Determination 2014/036

Regarding the compliance of building stability at 391E Karori Road, Wellington

1. The matter to be determined

Figure 1: Section through bank to south west of garage

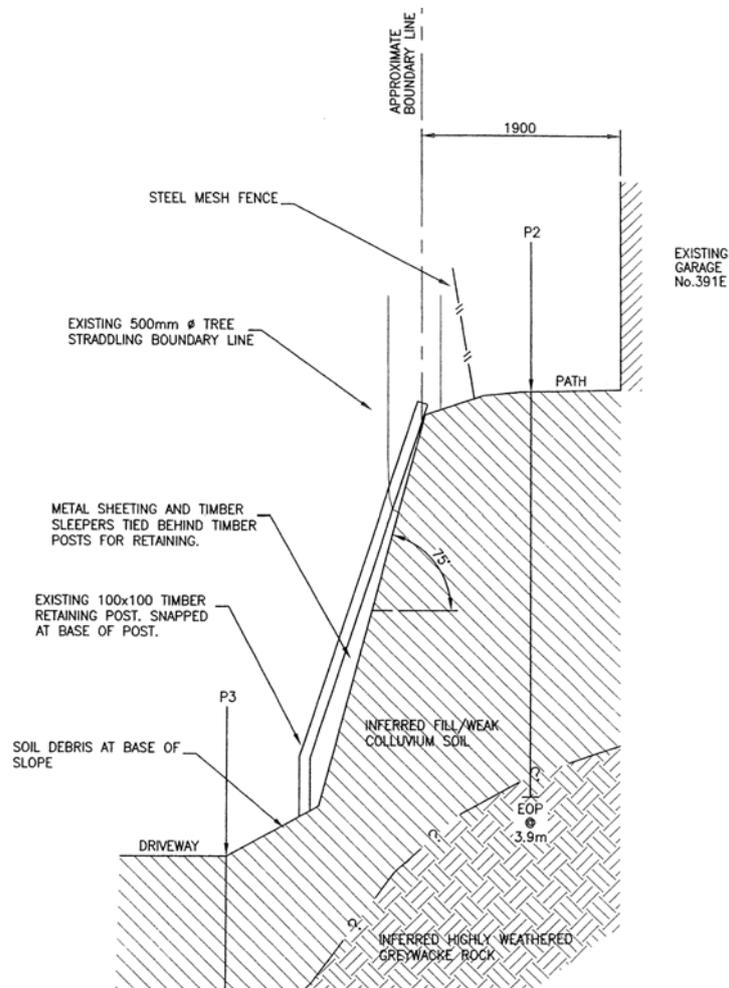
- 2.3 The consent documents include two Producer Statements - PS1 - Design: one is for seven steel beams supporting the upper level to the house, and the other is for alterations to the bracing schedule. Neither PS1 required specific site inspections by the engineer.
- 2.4 The site is a relatively flat subdivided section above Karori Road. The dwelling has been built at the rear (southern) of the section so that its back wall is approximately 3 metres from the site's southern boundary and its side wall (also the garage wall) is 1.9 metres from the western boundary.
- 2.5 A steep bank of up to approximately 3 to 4.5 metres in height and at approximately 70° to 80° to the horizontal⁴ runs along this western boundary, dropping down to the neighbouring property at 399 Karori Road (the neighbouring property), refer

Figure 2: Section through bank to south east of garage

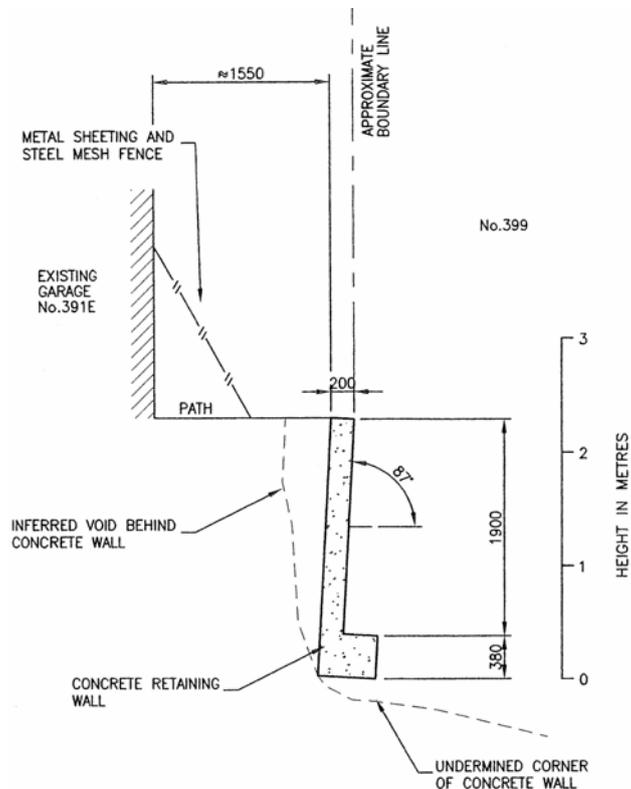
Figure 1. The bank transitions to a steep slope towards the north and to a raised garden and leaning concrete wall at the corner of the boundary to the south (refer Figure 2).

**Figure 3.1 'Relationship of foundation to sloping ground surface'
(from NZS 3604:1990)**

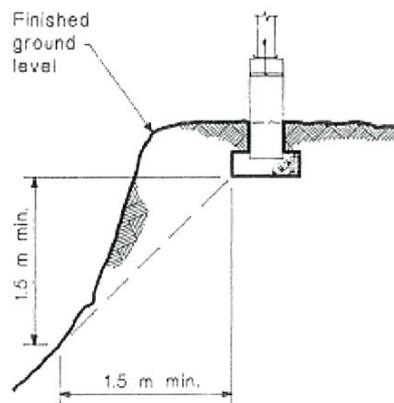
- There is no information about how the retaining structures supporting different parts of the western and southern banks would have looked in 1997, and there are no records held by the authority that indicate the banks or their retaining structures were regarded as a cause of concern at that time. There is also no evidence that the minor frizzling or deterioration of the bank has been caused by the proximity of the house as opposed to changes caused by the maintenance or removal of vegetation.
- The determination does not consider NZS 3604:1990, which was a means of establishing compliance with Clause B1. The authority referred to Clause 3.1.1(c) and Figure 3.1 of NZS 3604:1990.

- The plans showed the building set back 2.2m from the western boundary and 3.3m from the southern boundary. The design complied with Clause 3.1.1(c) of NZS 3604:1990 which, amongst other things, required Figure 3.1 to be satisfied. In the absence of other evidence as to site instability, there would have been no reason for the authority to seek further information about site stability.

**Figure 3.1 'Relationship of foundation to sloping ground surface'
(from NZS 3604:1990, Amendment 1, 31 July 1992)**

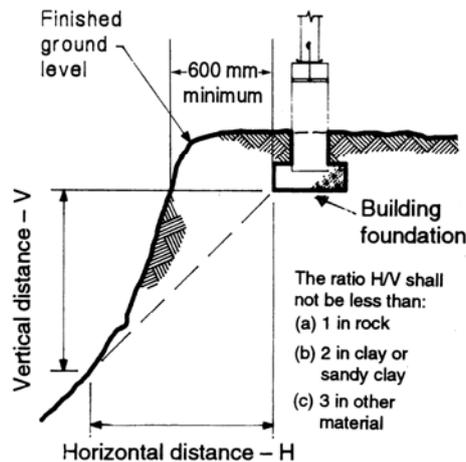
- 4.3.2 The authority is of the view that the foundation satisfies Clause 3.1.1 and Figure 3.1 from NZS 3604:1990 (refer paragraph 4.2.2, 4th bullet). However, Figure 3.1 was amended in 31 July 1992 to that shown above. As piles were required by the authority, the ground under the foundations was unlikely to be considered rock at the time of inspection. Assuming the ground is at best 'clay or sand clay', the bottom of the foundation is to be supported on ground defined by a 1:2 line taken from the bottom of the foundation. At the time of construction I consider the bank did not provide this ground support.
